LEVEL 2 REMODEL
SECTORS 5A, 5B & 6
COLLEGE COMPLEX
LOS MEDANOS COLLEGE
2700 EAST LELAND DRIVE
PITTSBURG, CA 94565

REQUEST FOR INFORMATION

RFI # 143

HVAC Ductwork in Restrooms 230 & 231

drawing title:
HVAC DEMO FLOOR PLAN
drawing no:
M1.0
drawing of

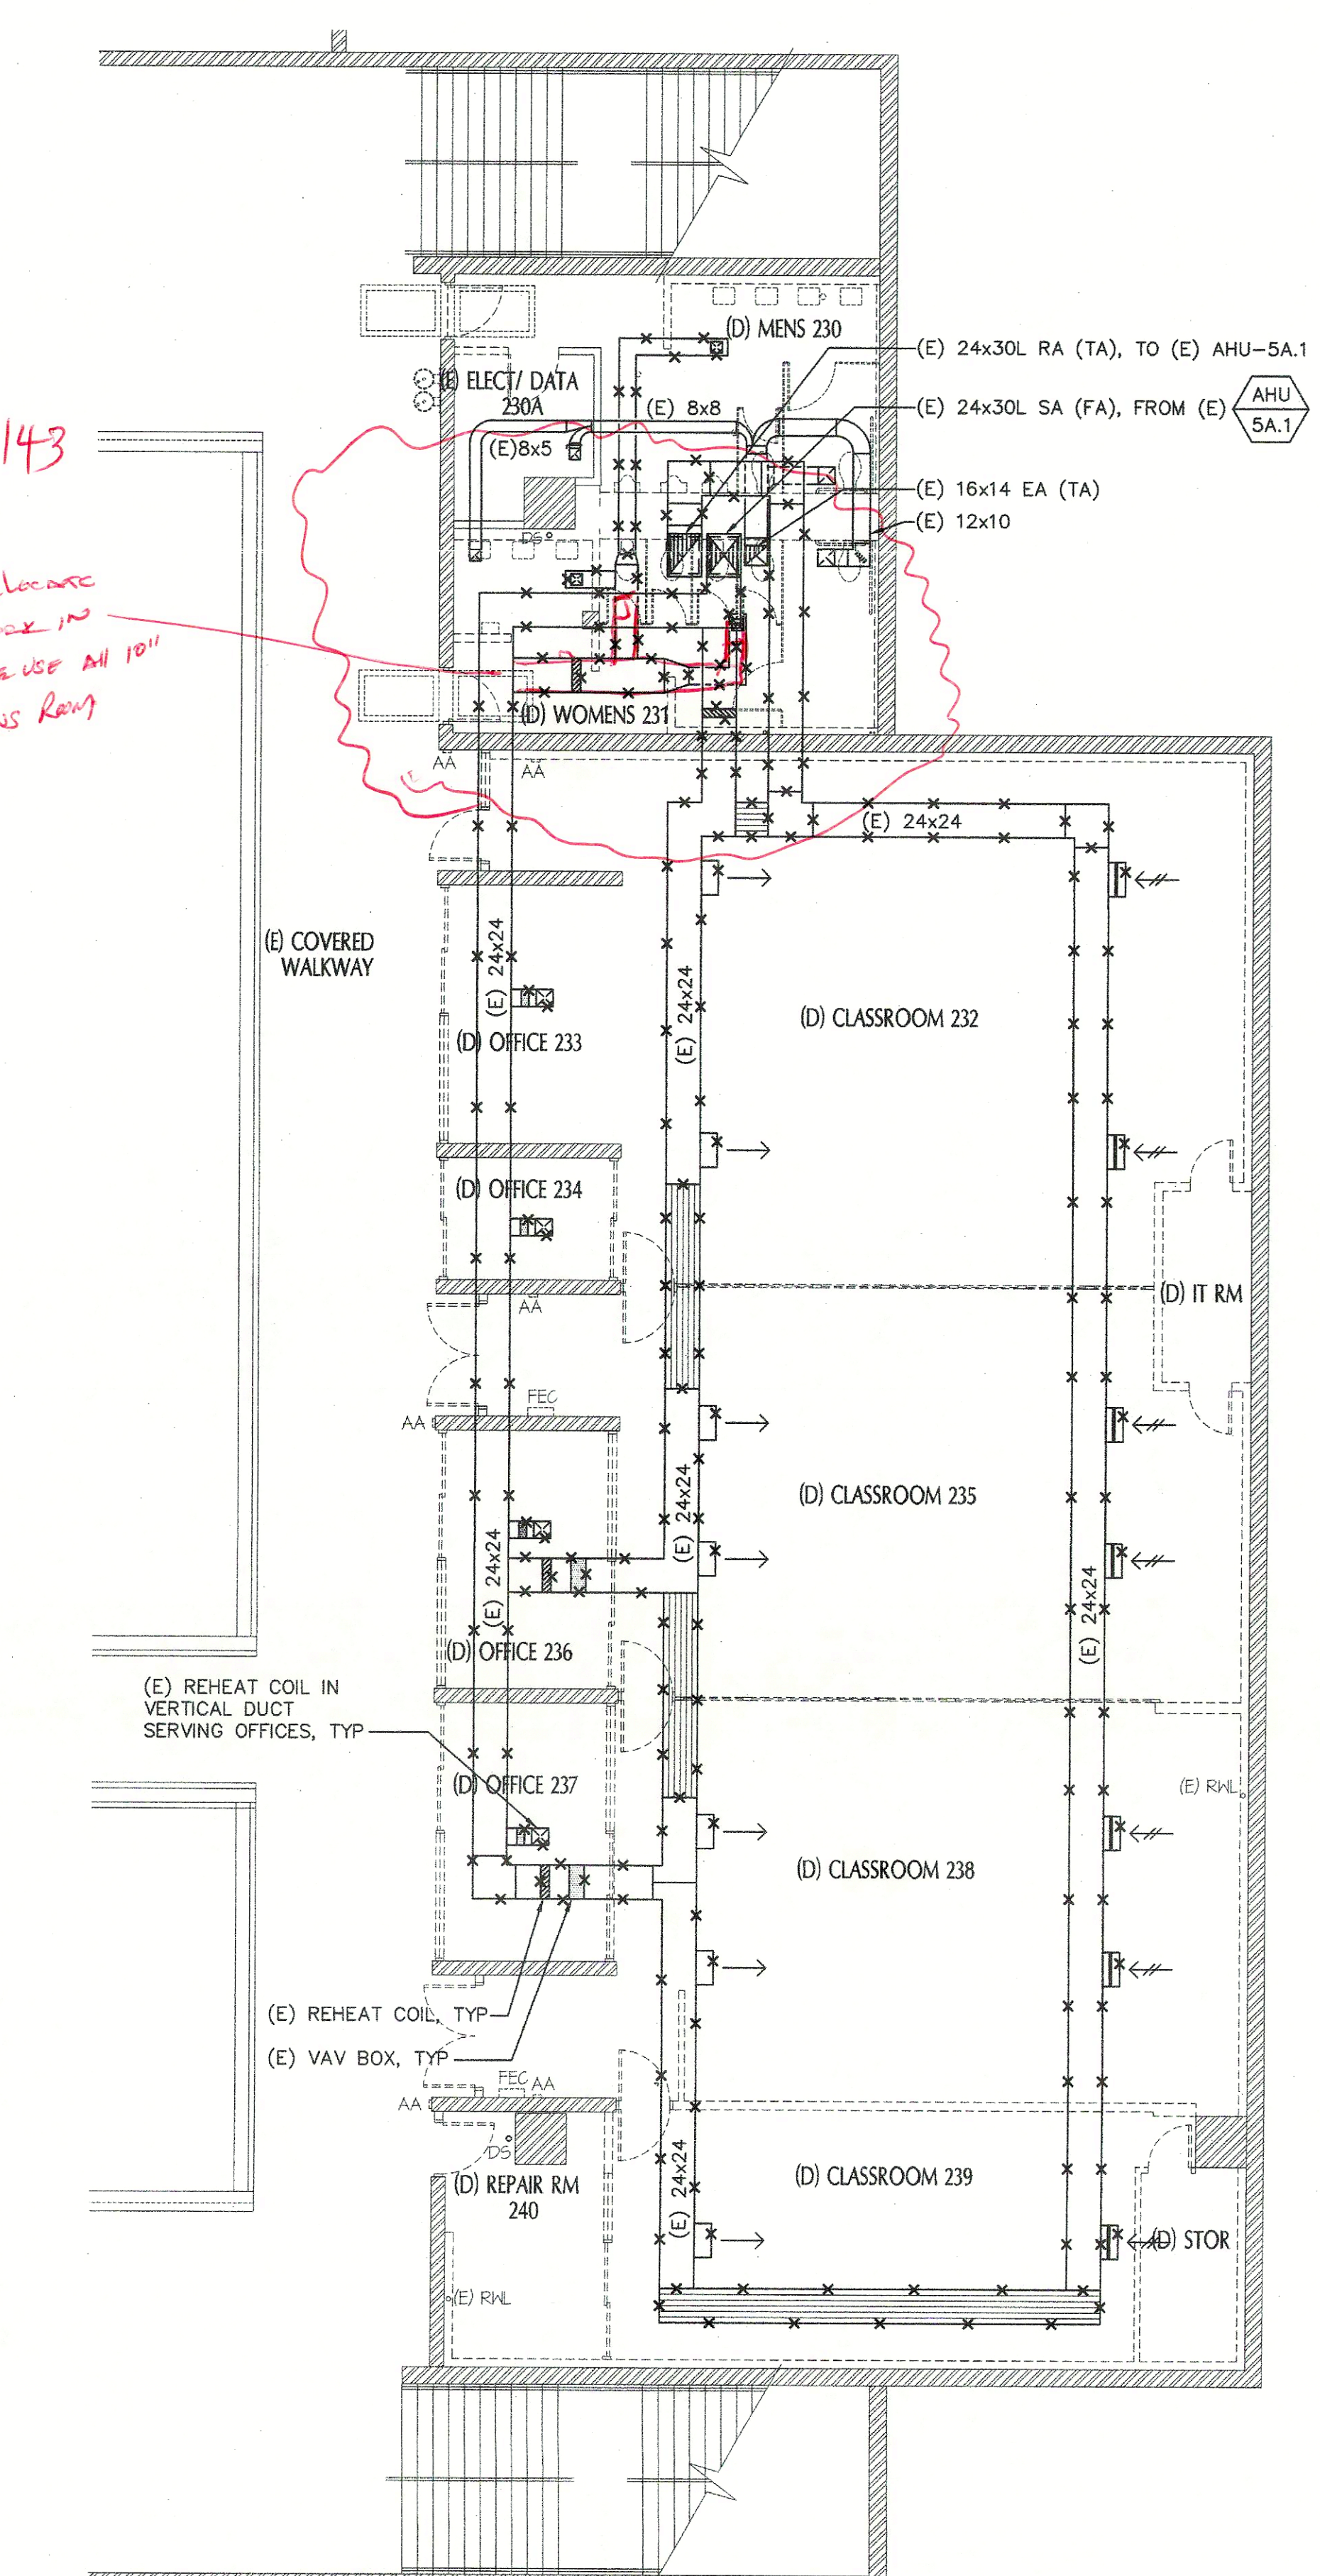
REF #143
Relocate
duct work in
Rm 200 / Re-use AHU 101
in main row

References
Drawing M2.1 Published

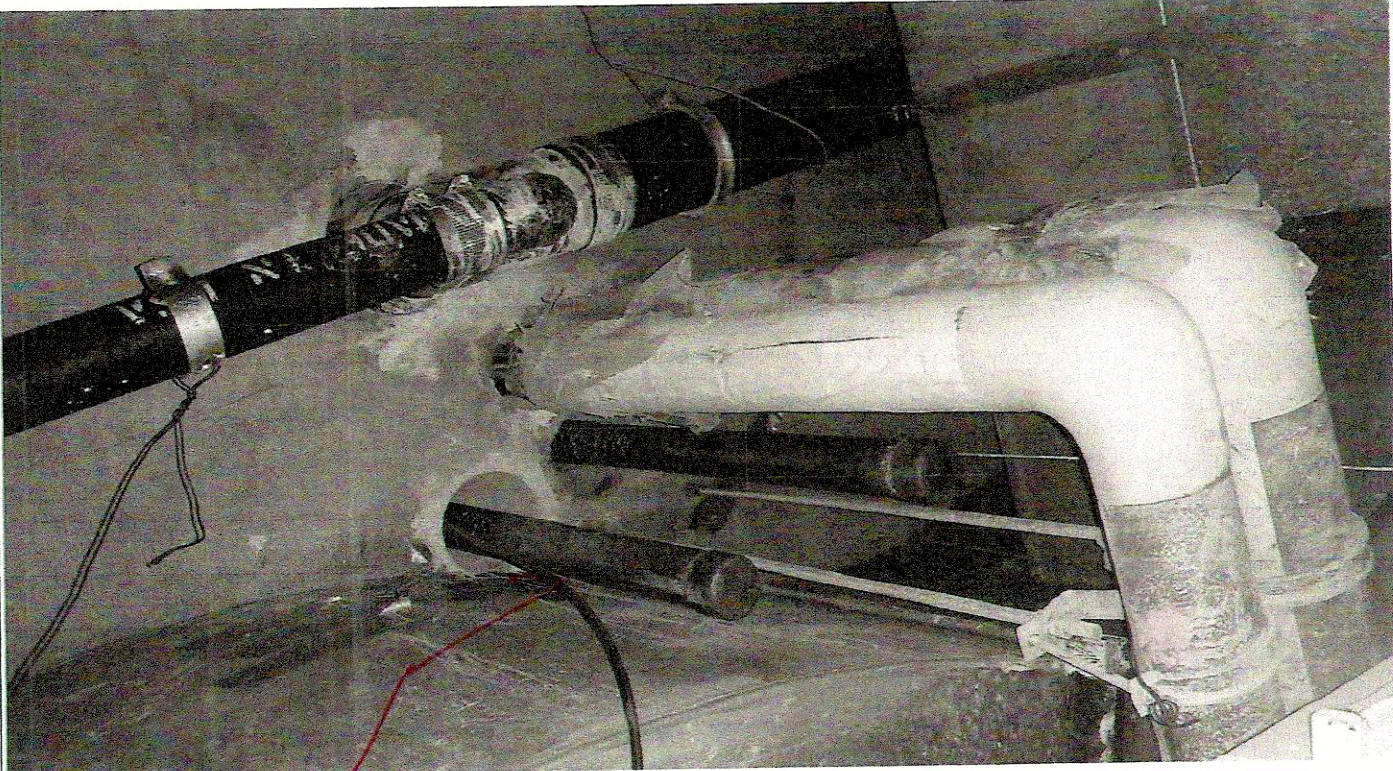
Request:
Reference is made to HVAC Piping plan 2/M2.0 on M2.1. The point of connection to the existing how water piping is shown in room 230. After extensive investigation, it appears that the existing piping at this location is not active and has been disconnected at a point further down the line. capped pipes were located and believed to have been done with the new Student Services project. Please indicate how we are to proceed.

Files
Images continued on next page.
Per telecon with Danny Dosier with Martinez Sheetmetal this morning there are live 1 1/4" HW lines coming down from the roof with isolation valves at the roof and terminating in Womens 231 with caps. Contractor to tie into the HW piping in Womens 231 to provide HW supply and return in Sector 5A. Demo abandoned existing piping to avoid any confusion in the future.
